**Waterwheel Booster Station
Solicitation Number: CO-00446
Job No.: 20-6008**

**ADDENDUM 1
September 22, 2021**

SITE PLAN
 WATERWHEEL SUBD.
 WATER BOOSTER SYSTEM
 SHEET NO. C1.1

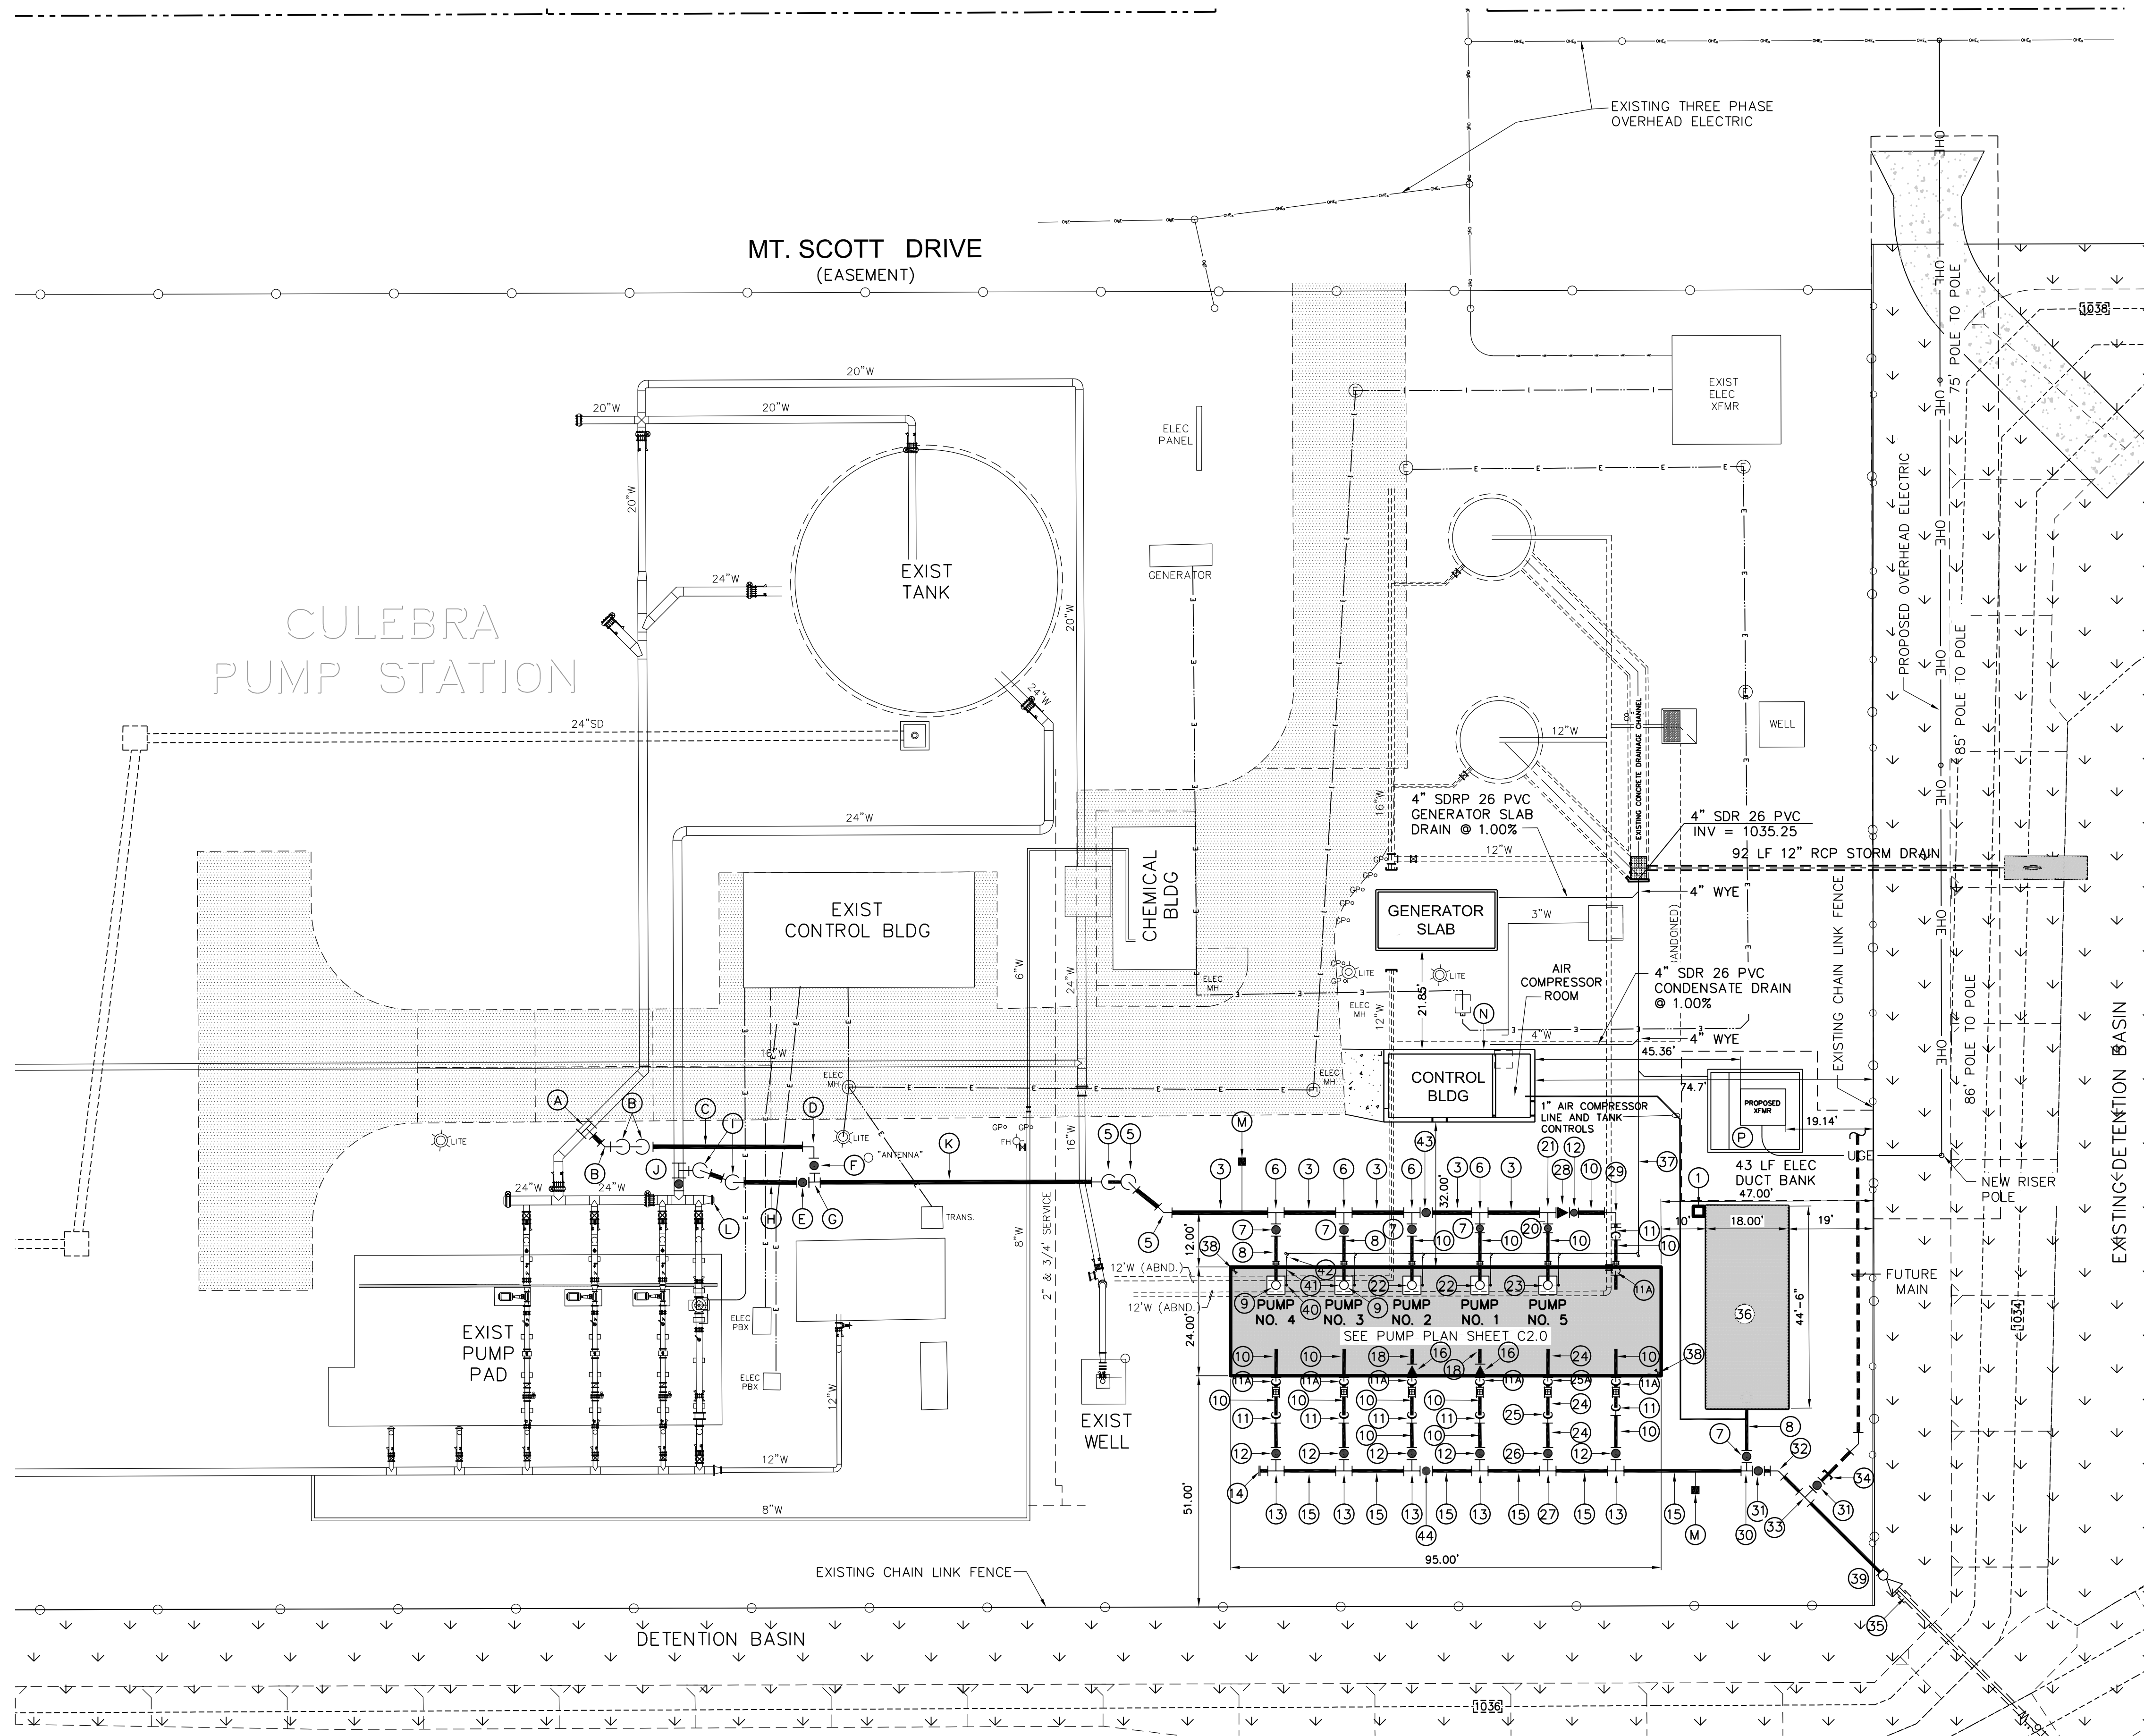
- 2. Would SAWS provide clarification that all piping within the plant is steel pipe as called out on drawing C1.1 & C2.0. Also, if all piping is steel pipe please clarify the references to the mechanical joint connection called out on drawing C1.1, C2.0 & C3.0.**

7. Several notes have been added to the Rebid Plans; Such as on Sheet C1.1 – General Note 3: All Piping within Plant is Steel Piping. Note #4 states MJ Joints shall be restrained. In the Key Notes – there are also several fittings and valves that are listed as MJ Fittings.

12. Ref Plan Page C1.1 – Key Note A & J. Please provide a detail for the tie-in if we are to use steel pipe.

1. Remove sheets C1.1 and C2.0 and replace with the revised versions attached to this Addendum. References to MJ fittings have been changed to FL fittings.

Response: All water piping in the plant is to be steel pipe. References to MJ fittings have been changed to FL fittings. See attached revised Sheets C1.1. and C2.0

Response: No Plan of Record Drawings showing the fittings and pipe used on the original plant were available for review. It is anticipated that a section of the existing pipe will be cut out and a tee inserted using weld-on flanges and/or approved couplings with harness clips.

REV	DATE	DESCRIPTION
1	9/22	CHANGED MJ FITTINGS TO FLANGED

SHEET NO.
C2.0

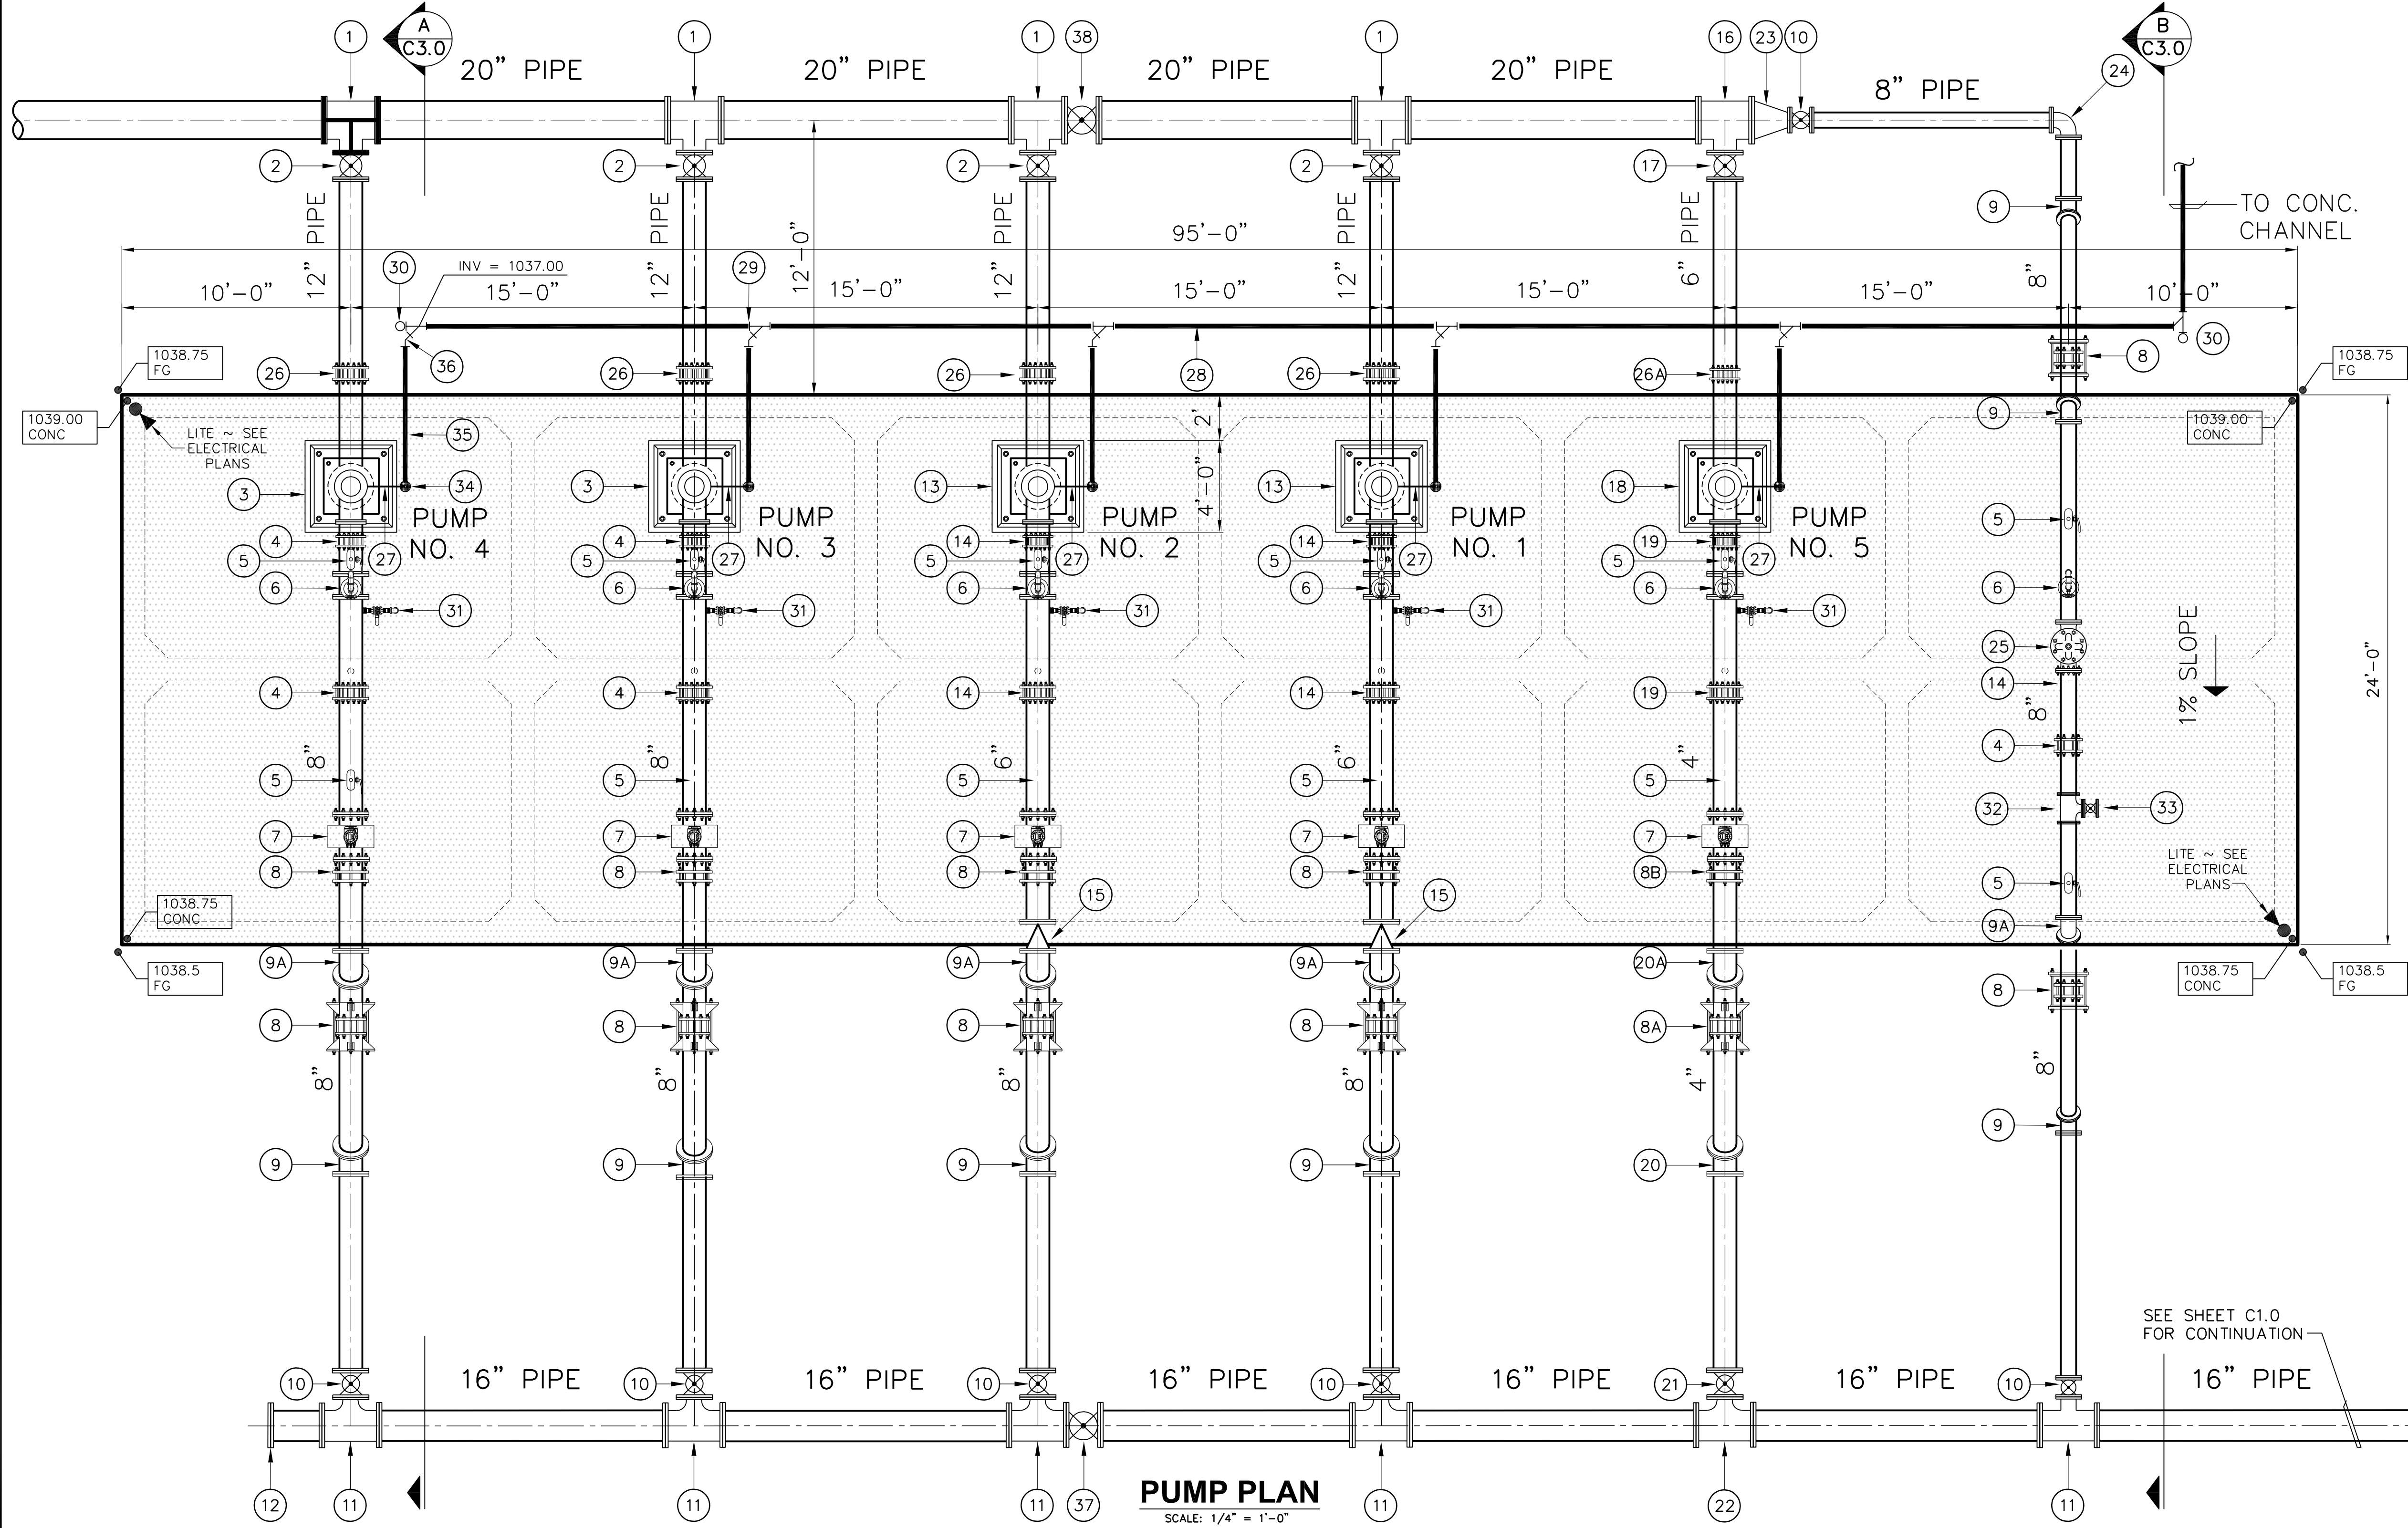
6. Were the plan documents updated at the same time as the specifications/front end documents? The front end documents reference penalties for failing to meet efficiencies (11 14 00 1.07.D.1 and 11 31 30 3.02) but do not specify the efficiencies required. Sheet 2.0 lists the overall (wire to water) efficiencies of each pump, is that still accurate?

17. On Sheet C2.0, Piping Note 1 states that all piping is steel pipe. Note 2 states that all mechanical joints shall have restrained joints. All key notes call out mechanical joint fittings. Mechanical joint fittings are typical of ductile iron pipe. Please advise if this pipe is to be steel or ductile iron, and what the coating/lining requirements are.

Response: Minimum Pump Efficiencies shall be 80% for Pumps 1-4 and 76% for Pump 5. See revised sheet C2.0 included with this Addendum.

Response: Please reference the response to Question #2. For lining and coating requirements refer to SAWS Material Requirements for steel pipe. For above grade steel pipe refer to Section 09 99 00 for painting requirements.

REV	DATE	DESCRIPTION
1	9/22	CHANGED MJ FITTINGS TO FLANGED
